## ADDENDUM No. 1

PROJECT: University Medical Center  
CV/CICU Renovation &  
NICU Renovation  
602 Indiana Avenue  
Lubbock, Texas 79415

DATE: 05/12/2025  
PROJECT NO.: 22307 & 22419

ISOLATION EXHAUST DUCT RISER DIAGRAM  
NO SCALE

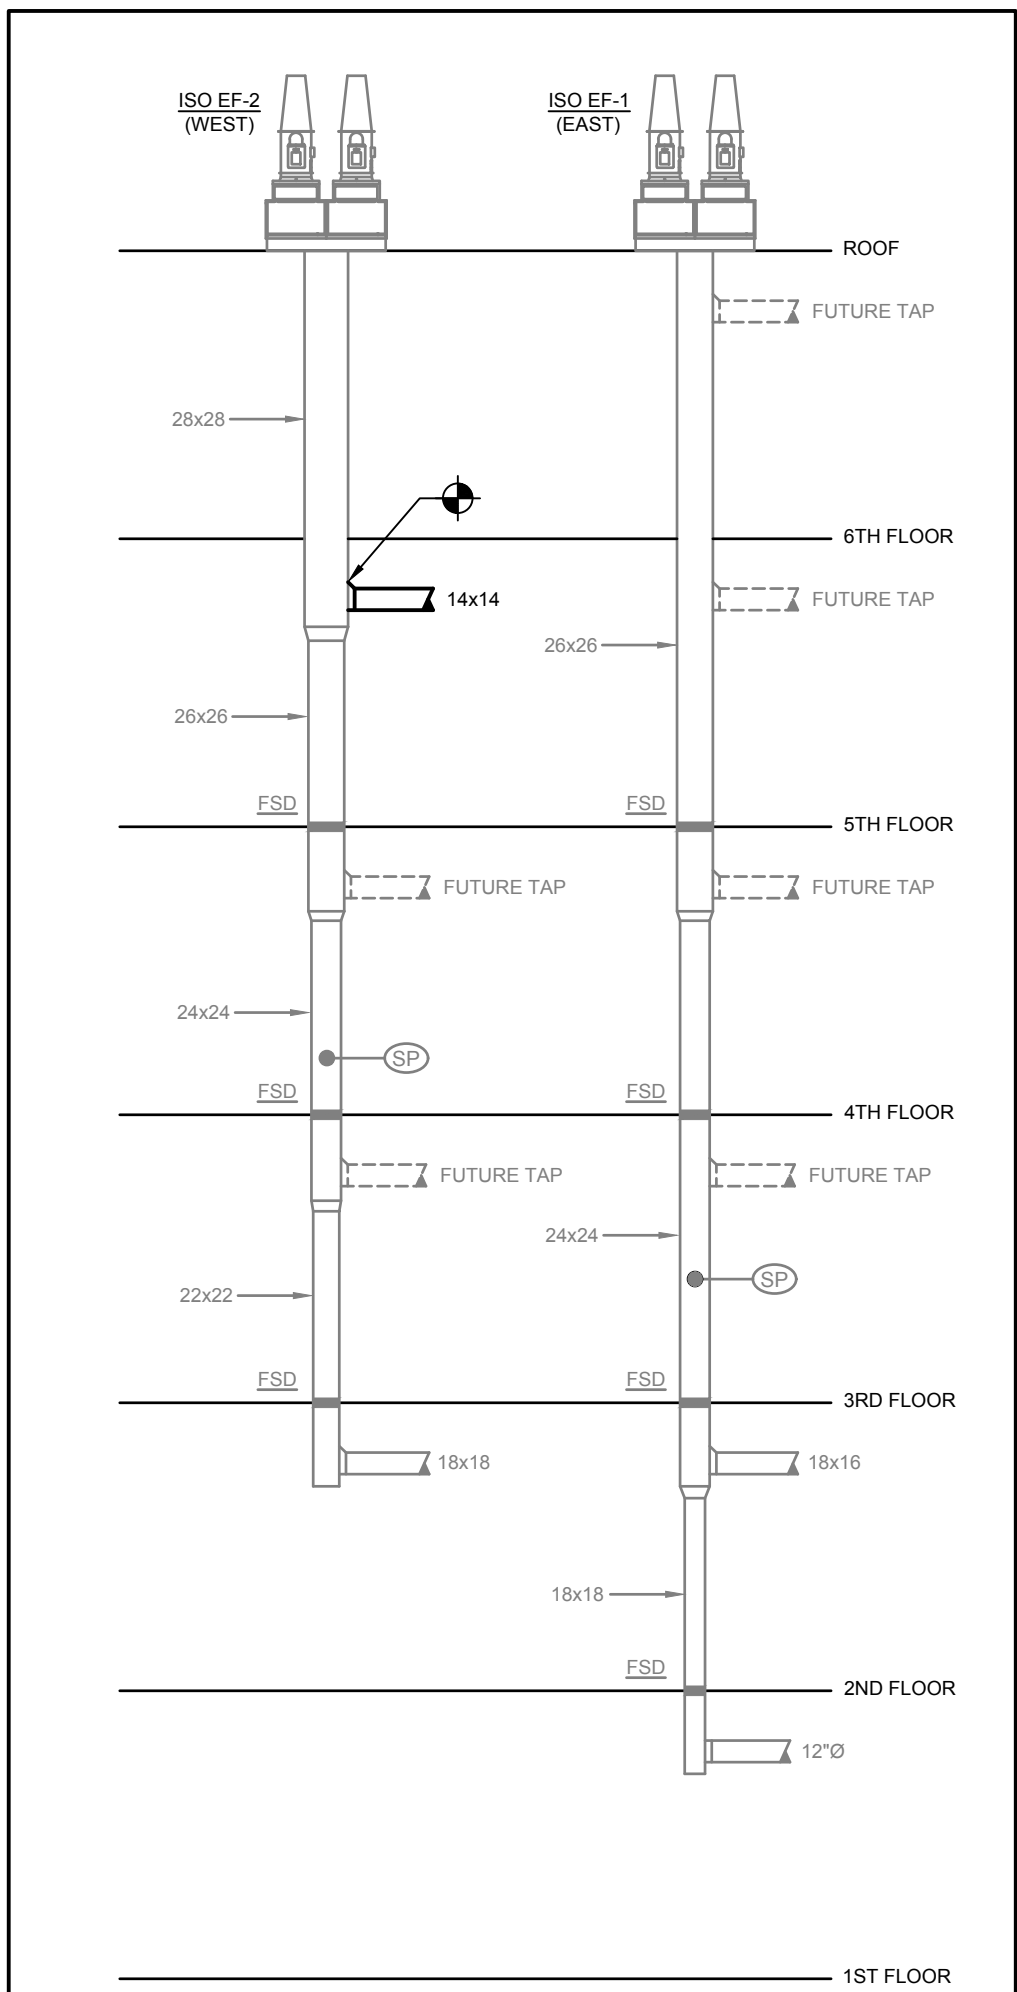
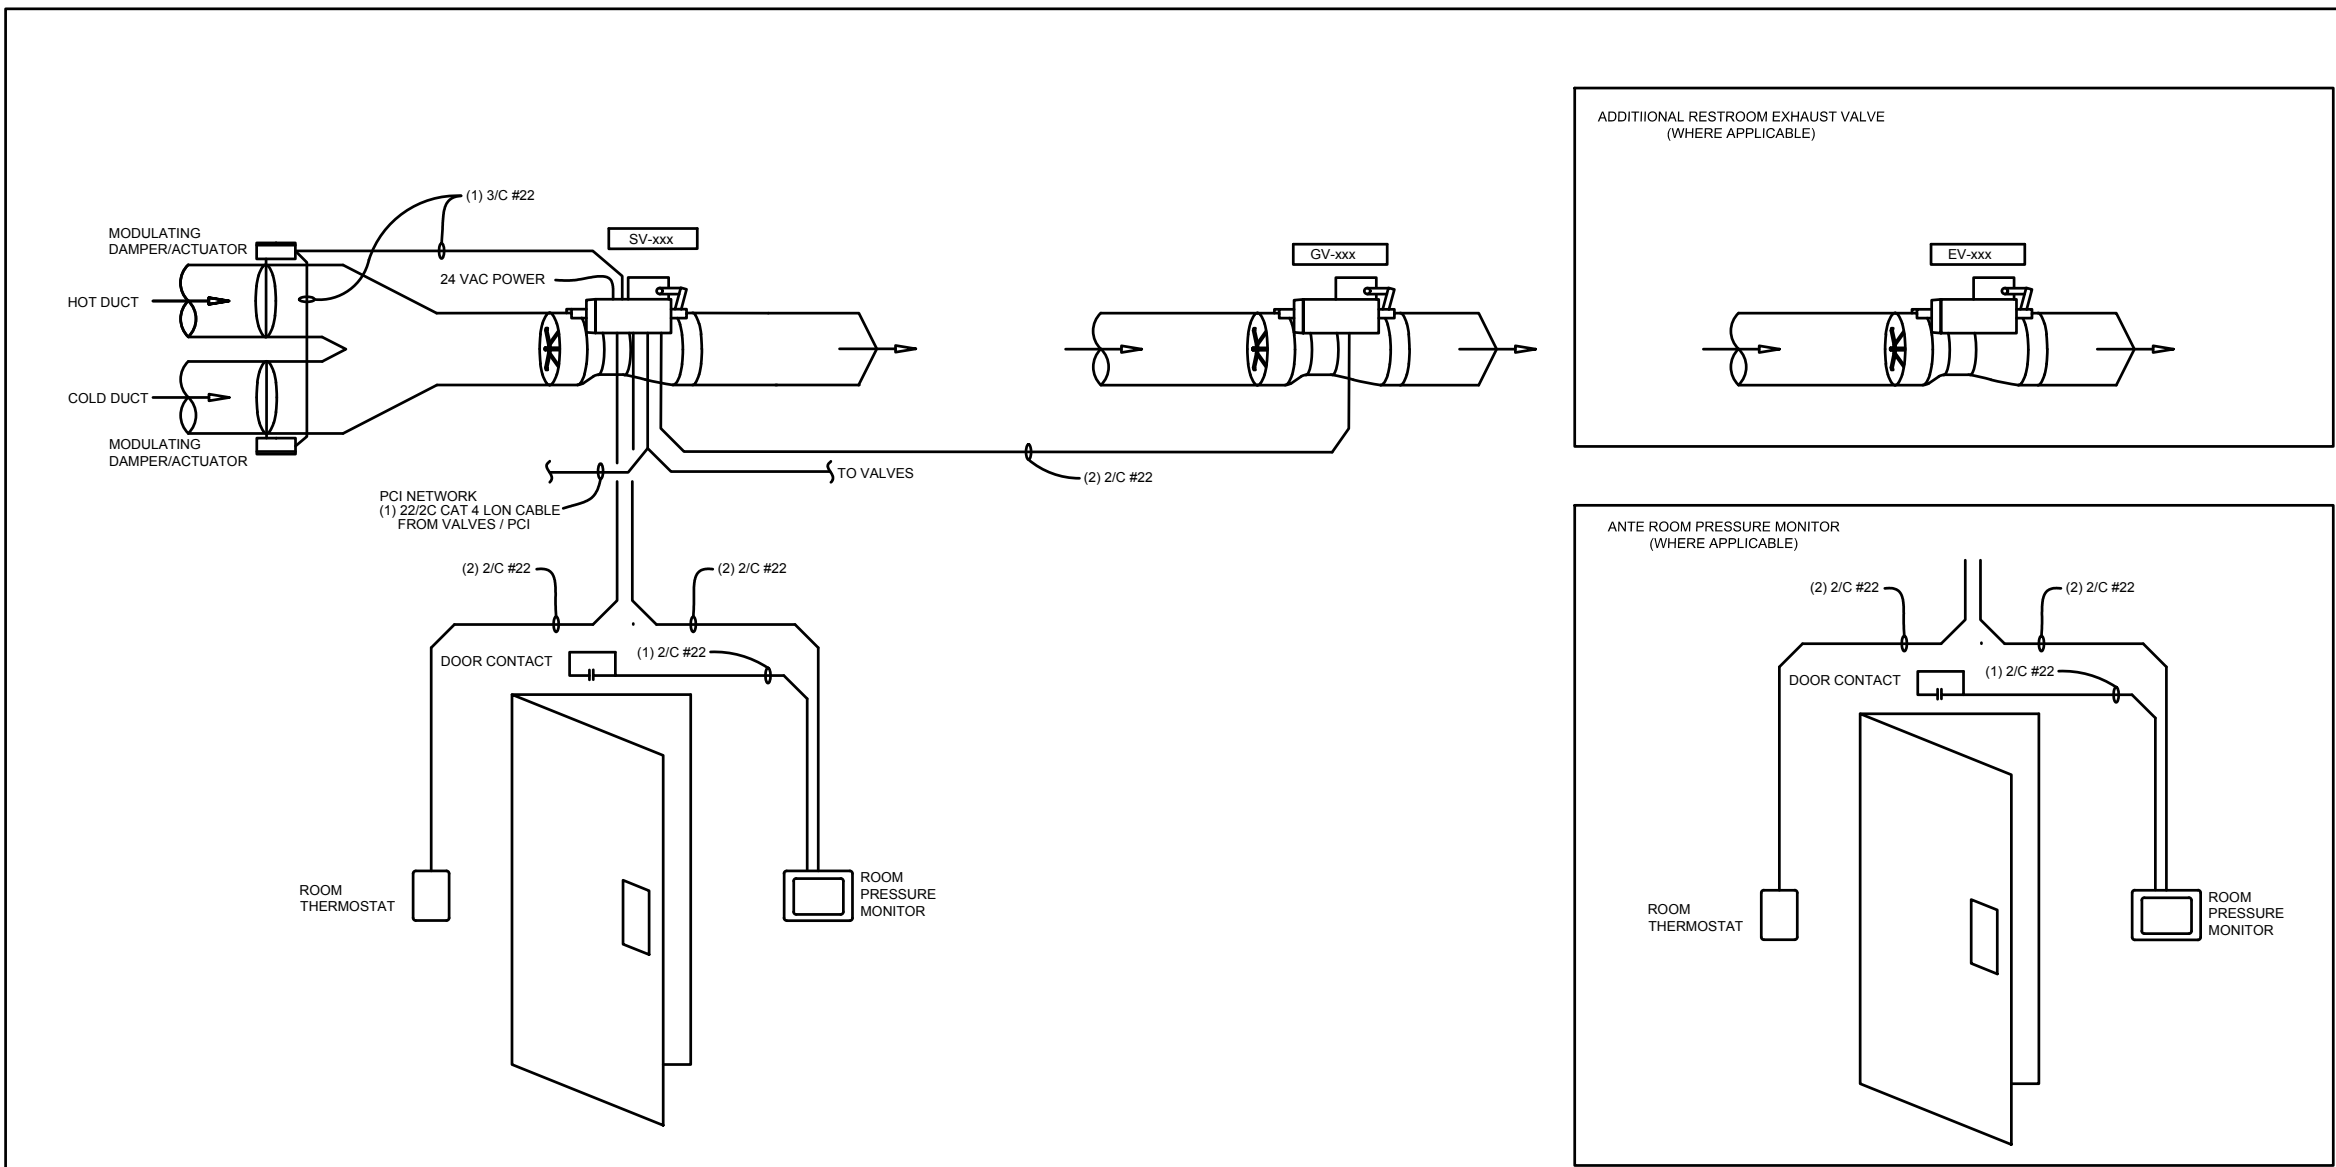
- a. VAV Box Schedule: 6V-21 and 6V-22 have been removed. 6V-57 has been added.
- b. Air Distribution Schedule: S-3 Supply Diffuser type has been added.
- c. Air Valve Schedule: Provide air valves as scheduled.
- d. Isolation Exhaust Duct Riser Diagram has been added.
- e. Dual Duct Supply Room Control Schematic has been added.

1/P1 PARTIAL SIXTH FLOOR PLAN - SOUTH - PLUMBING - DEMOLITION  
SCALE: 1/8" = 1'-0"

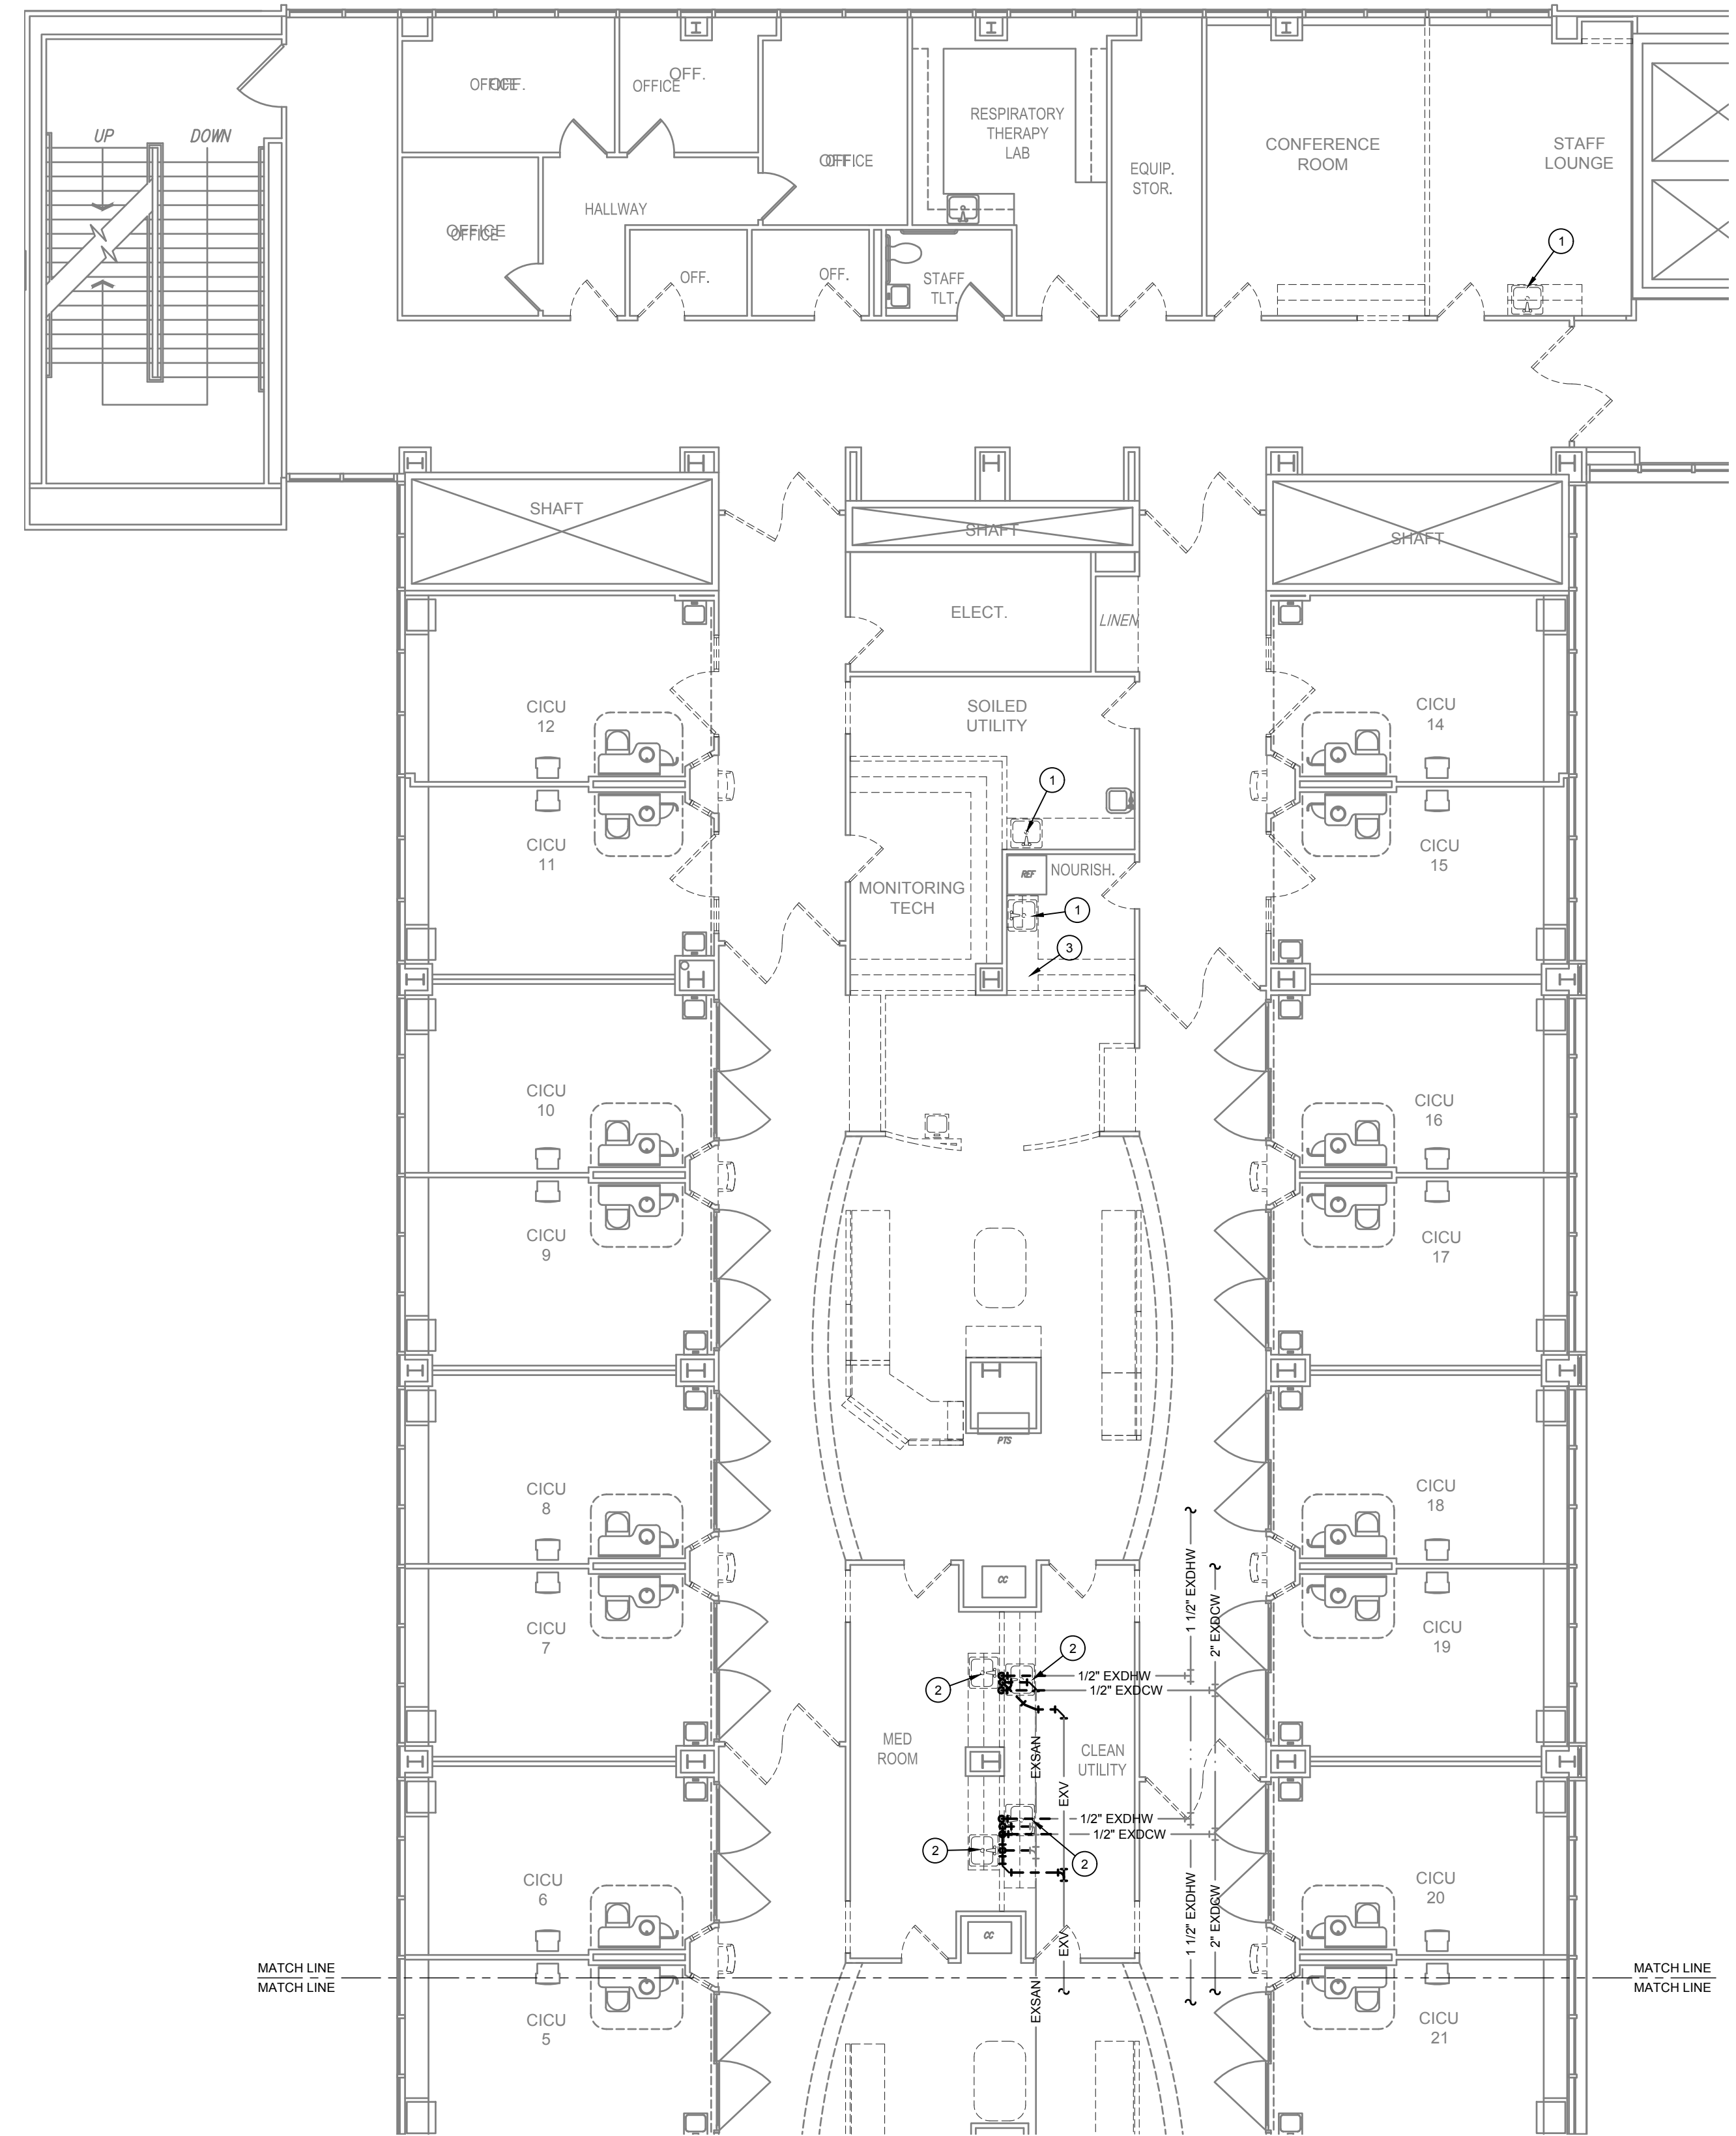
Item 1. Drawing Sheet P1:

- a. Remove the existing sink in CICU 1 Room, to be replaced with new sink.
